nature portfolio

Peer Review File

Review comment on "Pt nanoparticles on novel N-containing carbon 1 support …" by Islam, et. al

Fig. 3d STEM images of microtomed Pt/cPDA CL in - (i) and (ii) dark field and (iii) bright field mode. The marked regions are the cross-section of Pt/cPDA catalysts highlighting that the Pt particles are located at the exterior of the cPDA support.

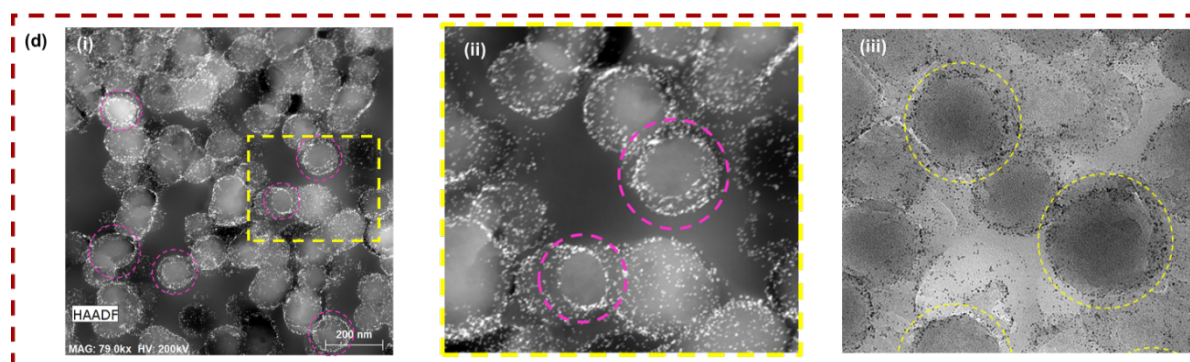
• This work does not take into consideration the Pt location or the pore opening of the carbon supports as it has been proven to affect significantly mass transport resistance and mass activity. A discussion and comparison on this effect with their work is needed in order not to mislead readers regarding the effect of the carbon support on fuel cell performance. In addition the authors failed to mention or demonstrate the Pt location with respect to their carbon support. This is very critical as in the manuscript the authors are comparing Pt accessibilities.

Response: We agree with the reviewer about the influence of Pt location on the support. In the original submission, we had included a video (as a SI) obtained from 3D TEM of our Pt/cPDA catalyst showing that most of the catalyst particles are located on the surface of the cPDA support. Perhaps we should have highlighted in the main body text that the 3D TEM indicates that a majority of Pt catalyst are present on the surface of the support.

We have reorganized the manuscript to discuss the Pt location issue specifically. The Pt location is now discussed in the section "**Pt/cPDA catalyst characterization".** The location of Pt catalyst for the Pt/cPDA can be visualized from the **3D TEM video** submitted as well as the TEM images of the CL with sectional cuts of the PDA support particles (see image from Figure 3 reproduced below).

Fig. S12. (b) Tafel plots of Pt/cPDA catalyst at varying temperature (*70 ℃ and 80 ℃*), *Condition: 140 kPa$_{abs}$ pressure, in H$_2$/O$_2$ (0.3/0.5 NLPM); voltage was corrected for iR (HFR) loss and current density was corrected for crossover loss.*

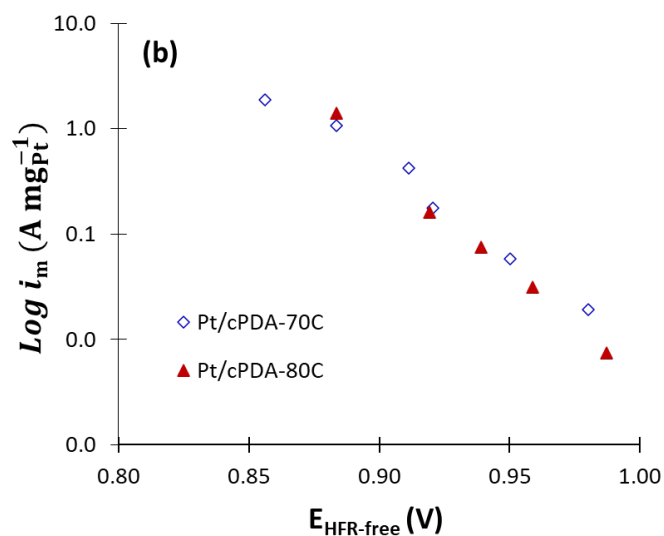
o Figure 5c contains data from Reference 16 for comparison. The data acquired form reference 16 where obtained at different cell temperature (80°C with 100%RH under 100kPaabs,out pressure of both anode and cathode)- which is known to influence degradation kinetics. So one has to wonder if this comparison is valid to show their catalyst superiority. Please comment.

Response: We understand the reviewer's concern regarding the activity comparison at the similar condition. We have recorded the activity data at both 70 ºC and 80 ºC; however, the

difference is insignificant. The comparison between 70 ℃ and 80 ℃ Tafel plots are included in the SI in Figure S12b (given below).

Fig. S5. (b) RDE voltammogram under O$_2$ atmosphere at varying rotation speed, and (c) corresponding Koutecky-Levich plot of Pt/cPDA. Sweep rate - 10 mV/s. Electrolyte – 0.5 M H$_2$SO$_4$ (RE - RHE; CE – Platinum).

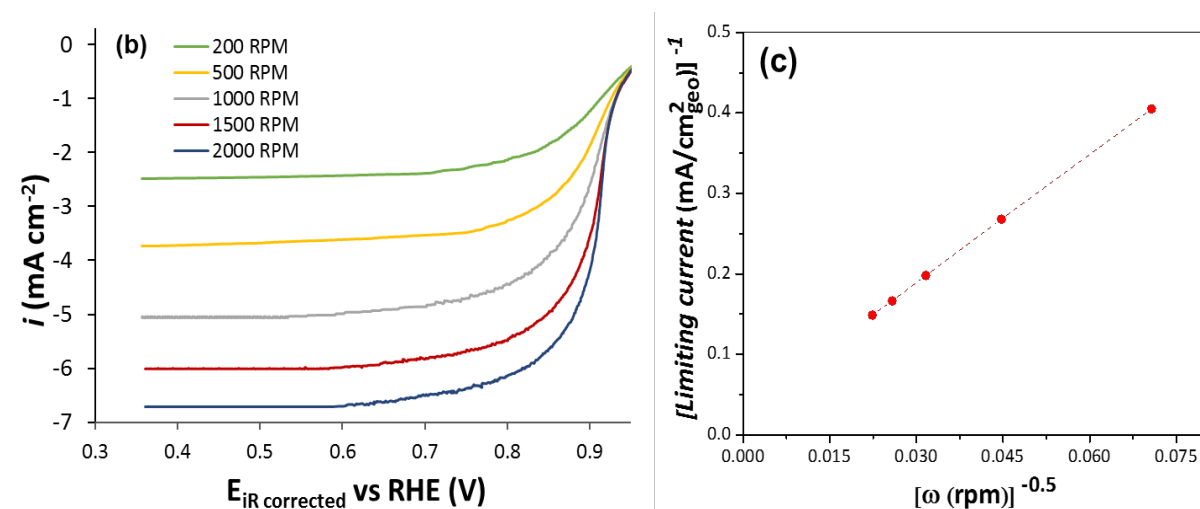
Comment: - the shown RDE curves look very strange, both for the tkk and the home-made catalyst. The diffusion limited currents do not overlap and no rotation dependent plots are shown also it is written that they were recorded.

Response:. We share below the rotation-dependent plots and corresponding Koutecky-Levich plot for Pt/cPDA catalyst (provided in SI; Figure S5b and S5c). The Koutecky-Levich plot for Pt/cPDA catalys showed the expected linearity, which were considered as an auxiliary indicator that the data were reasonable.

As stated above, since we had deemed the ORR activity in MEA to be the main information and activity in liquid electrolyte to be supplementary result, we had not included rotation-dependent plot
